# **ATTACHMENT 6D**

**ARTERIAL LIFE CYCLE PROGRAM  
REQUEST TO SUBSTITUTE PROJECT OR CHANGE SCOPE OF PROJECT**

Name of Original Project	CAP Canal South Frontage Rd: Loop 101 to Frank Lloyd Wright
--------------------------	---

Name of Rescoped/ Substitute Project	Loop 101 Southbound Frontage Rd Connections
--------------------------------------	---

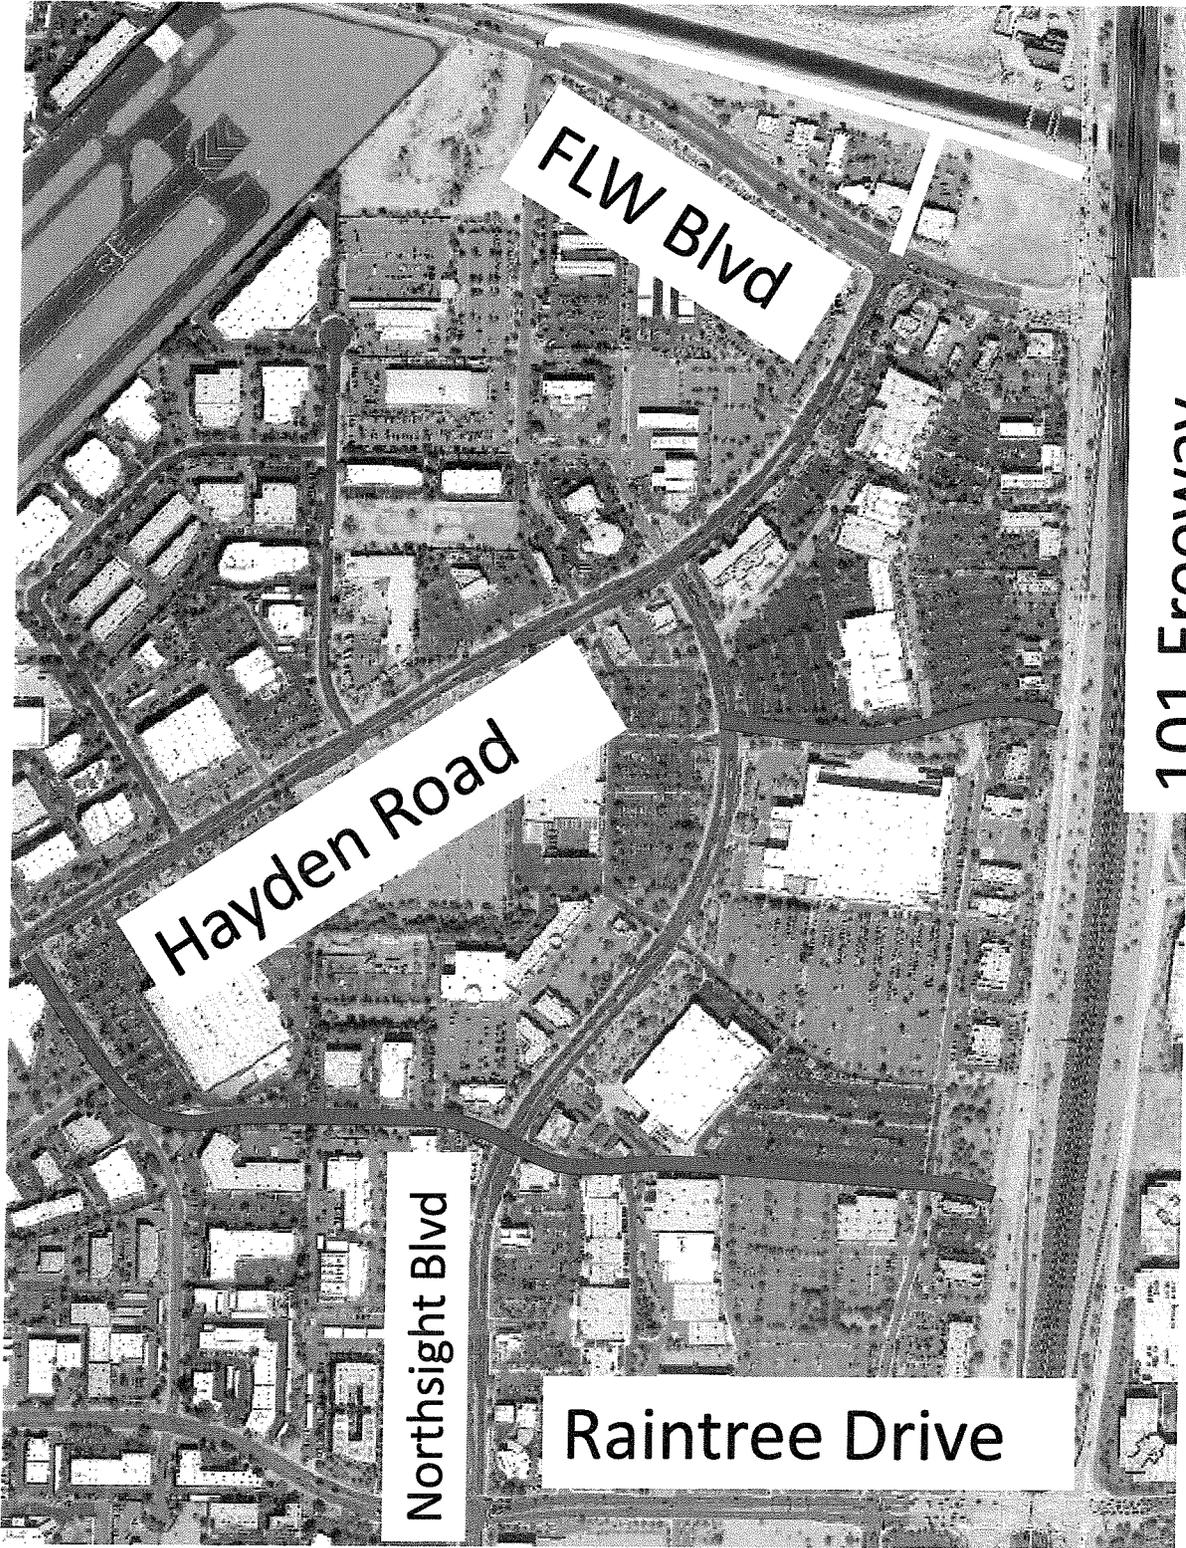
Description of Rescoped/ Substitute Project	Name Change and rescoping for this project. This project will include the previous CAP Canal South Frontage Rd along with improvements to other connections to the south Loop 101 frontage Road. These improvement aim to improve the flow of the arterials to the Frontage road for regional connectivity and relieve the interchanges at Frank Lloyd Wright and Raintree.
---	---

Please explain the reason for requesting to substitute or rescope the original project.	This request to change the name and rescope this project comes from working with residents, businesses, and the Transportation Commission and is reflected in the Airpark Area Phase I study. It identifies additional elements to improve the operation of the Loop 101 south frontage road. These projects combined will alleviate the traffic on the arterials in the Airpark Area.
---	--
